■BODY SHELL

140BO102

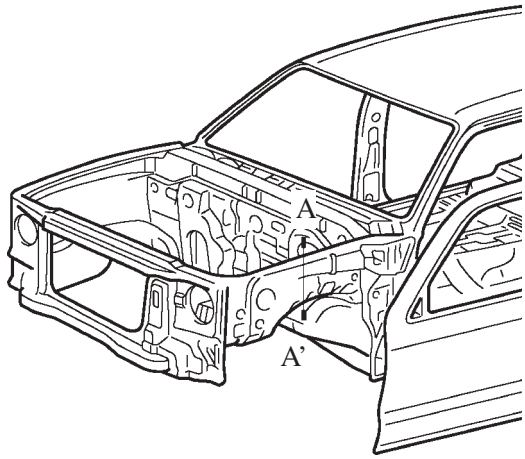
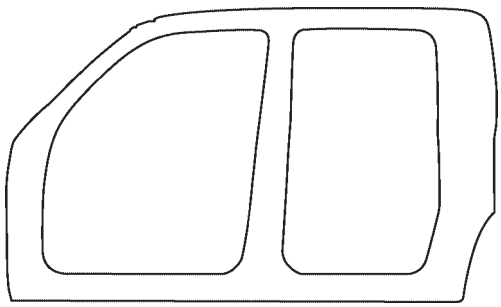
- The body of the new Hilux has been made highly rigid through the adoption of larger and closed cross section members and reinforcements, and optimized allocation of materials.

140BO27

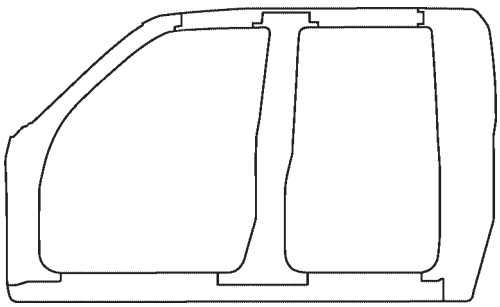
- The side member panel has been integrated in order to realize excellent panel precision and joining rigidity.
